**3GPP TSG\_CN  
Plenary Meeting #9, Oahu, Hawaii  
20<sup>th</sup> – 22<sup>nd</sup> September 2000.**

**Tdoc NP-000557**

**Source:** TSG\_N WG 4  
**Title:** CRs to R00 Work Item Technical Enhancements and Improvements (TEI)  
**Agenda item:** 7.19.4  
**Document for:** APPROVAL

**Subject:** Correction to MSC-A handover SDLs

Figure 19.2.2/1 (sheet 8 of 13): Process MSC\_A\_HO

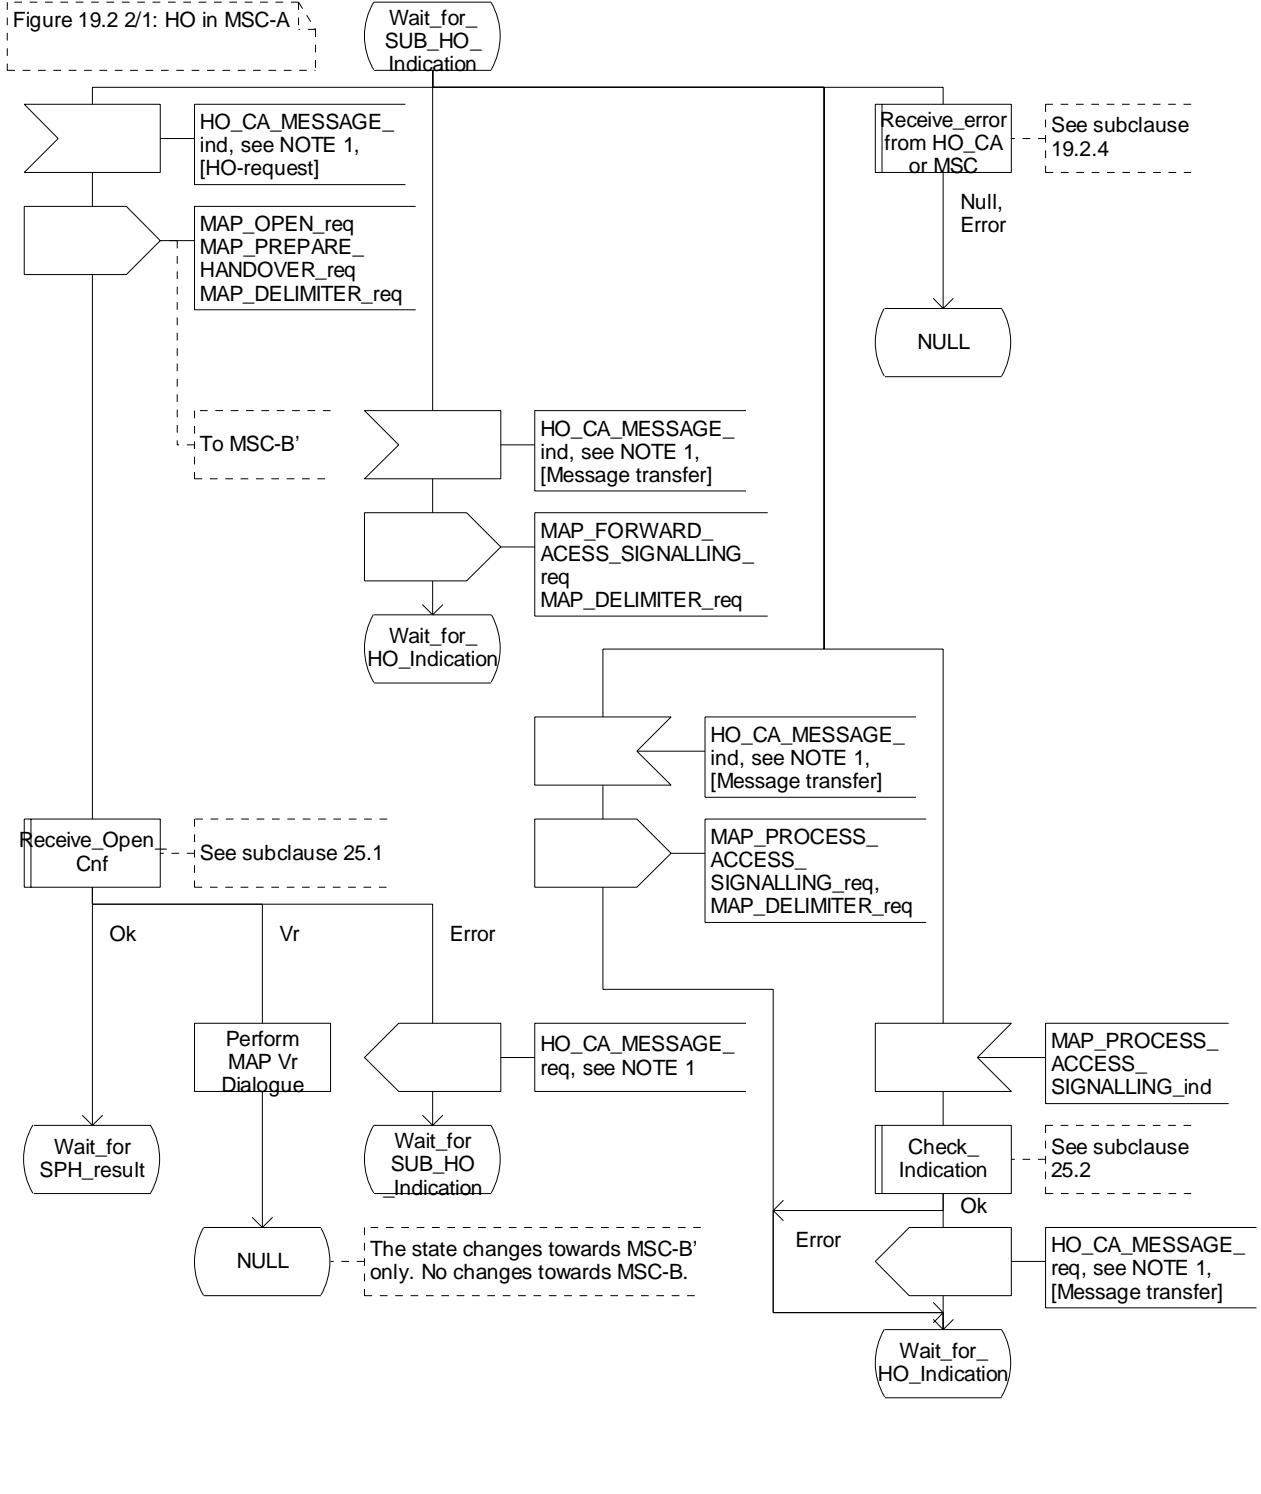
- The new figure 19.2.2/1 (sheet 8 of 13) seems to represent more than just editorial changes (as indicated by CR 143 coversheet)
- Replaced MAP\_Prepare\_Subsequent\_Handover respond by MAP\_forward\_access\_signalling Request
- Replaced Call on MSC-B by Wait\_for\_HO\_indication
- Replaced Wait\_for sub\_ho\_indication by Wait\_for\_Ho\_indication

Figure 19.2.2/1 (sheet 8 of 13): Process MSC\_A\_HO

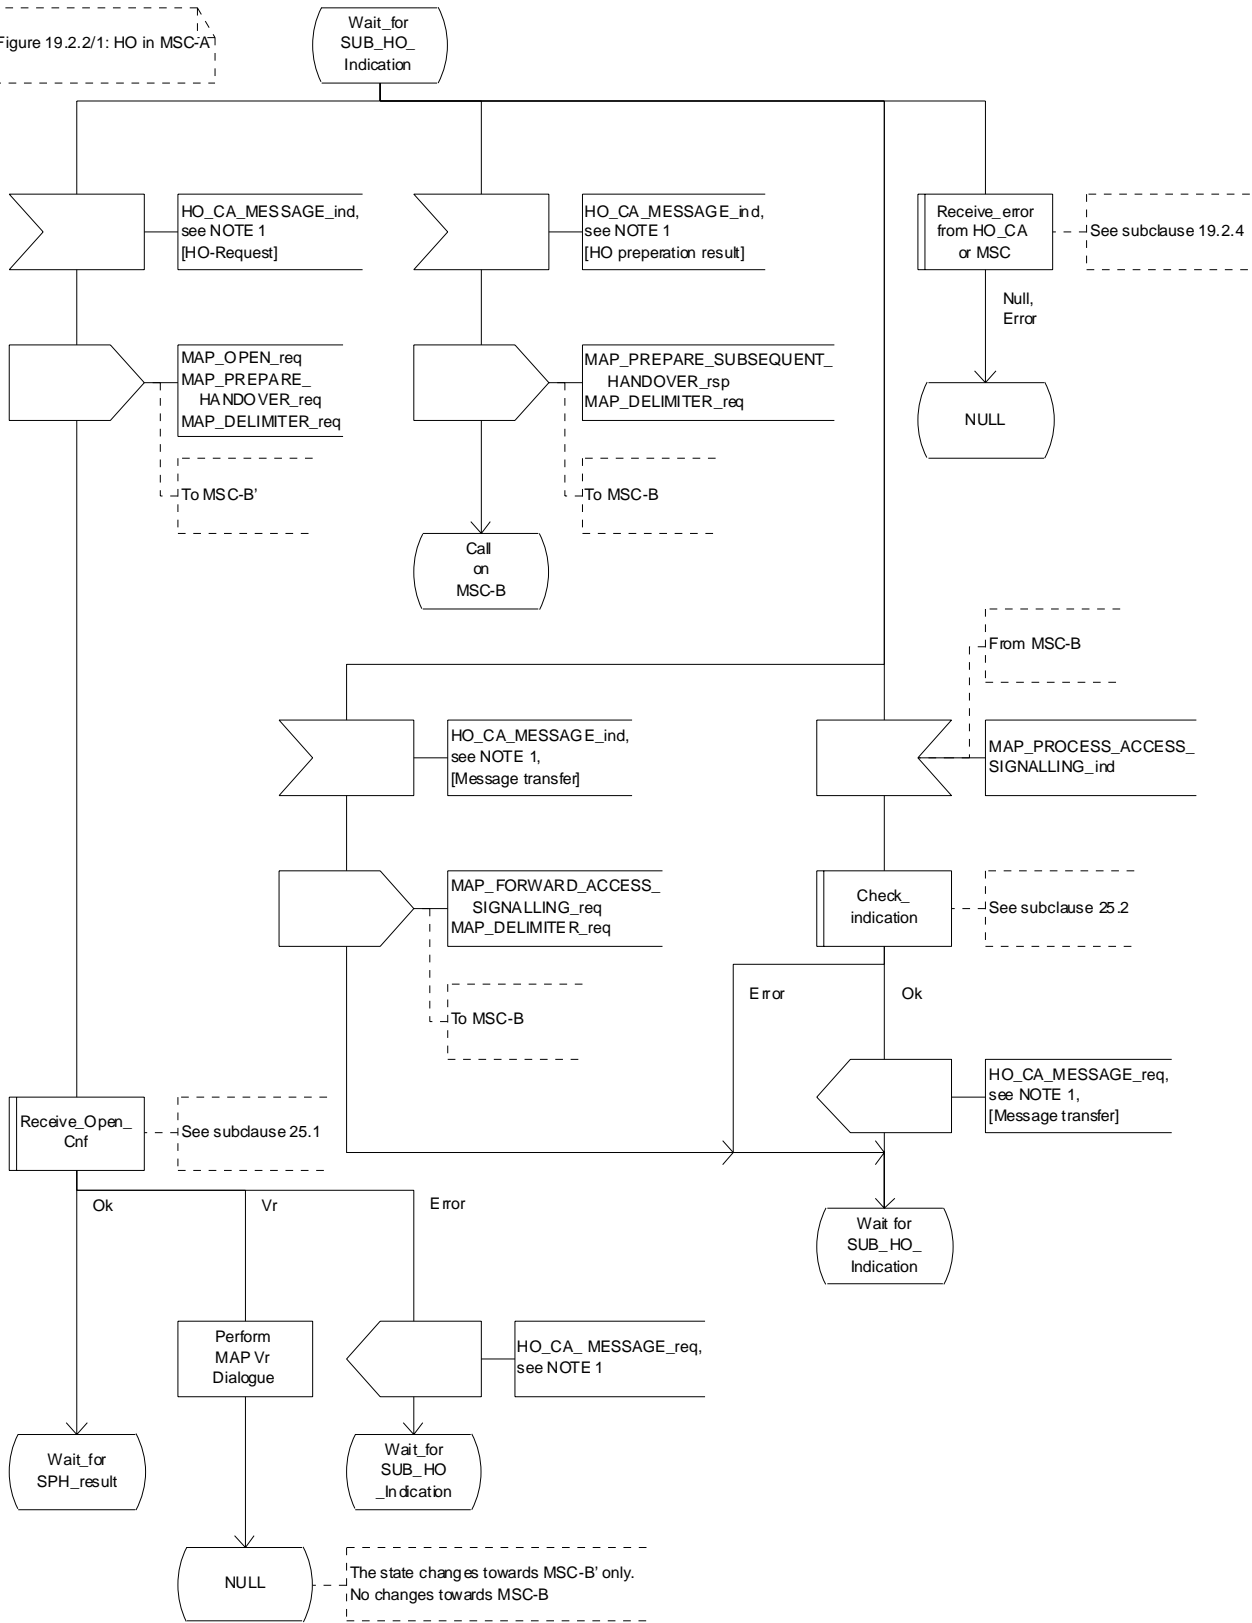
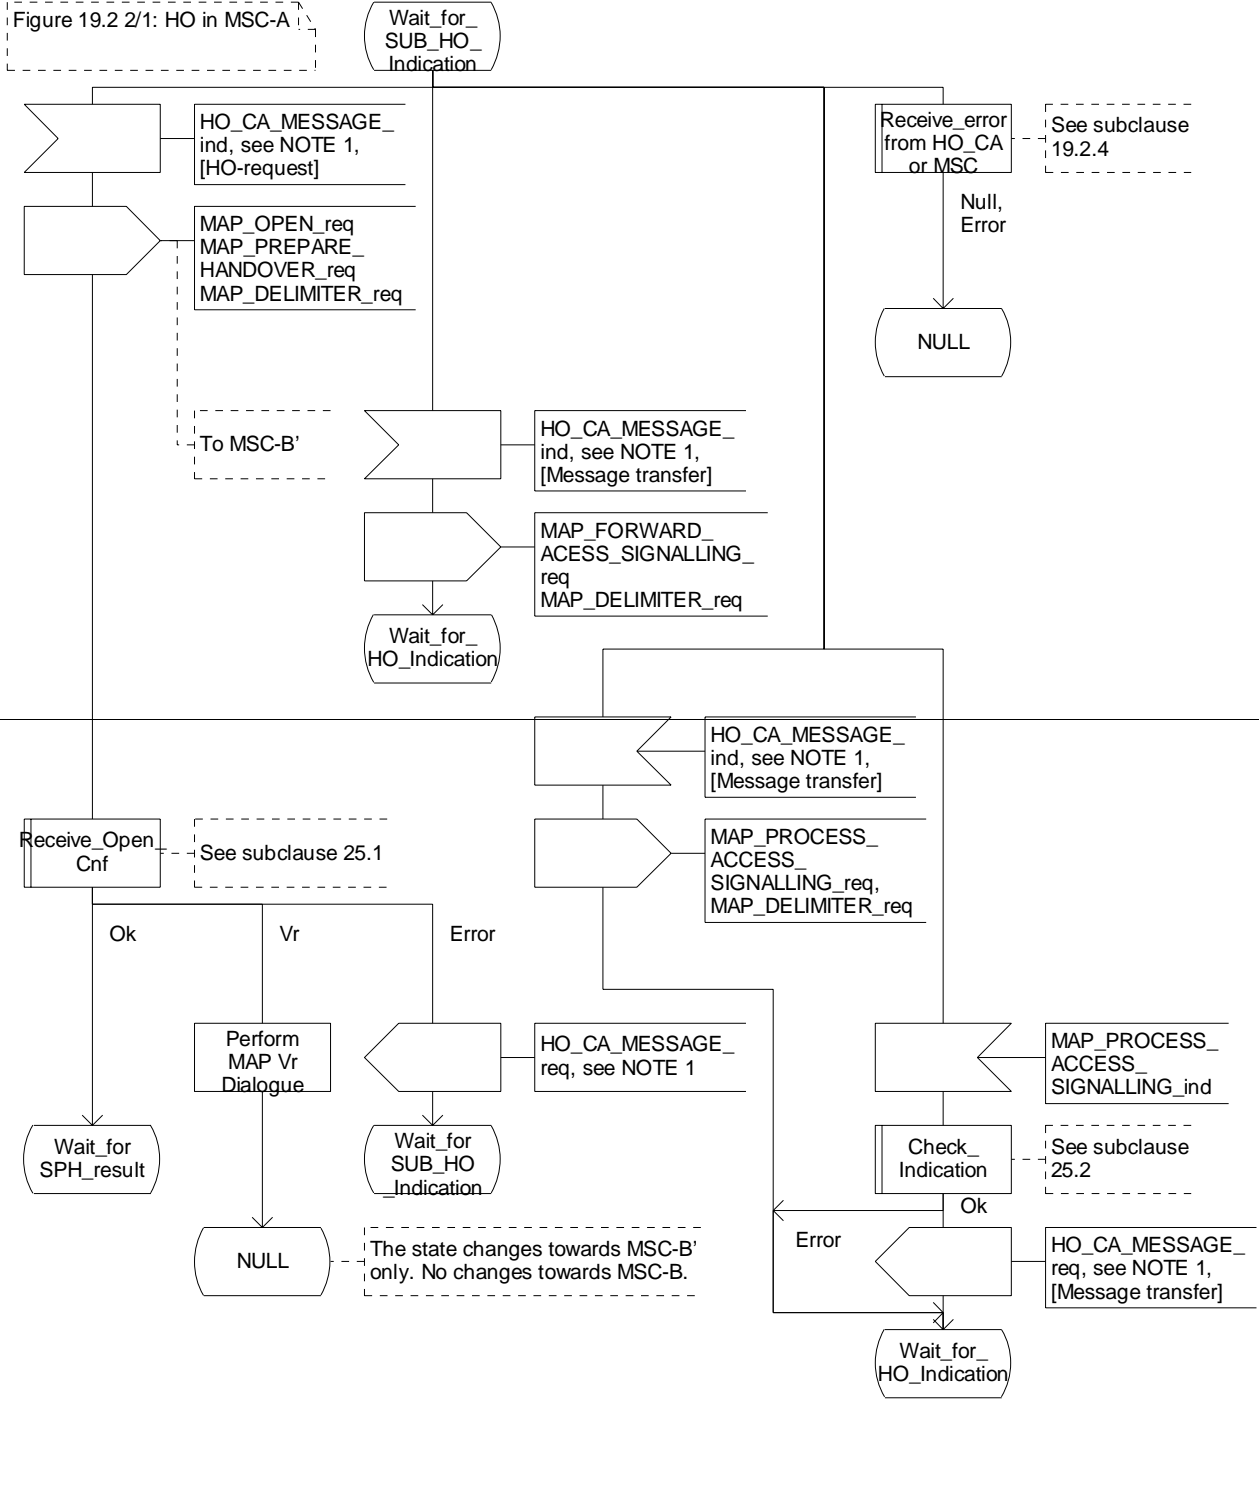
**Other comments:** Header for sheet 8 needs changing 19.2.2\_1.7(12) -> 19.2.2\_1.8(13)
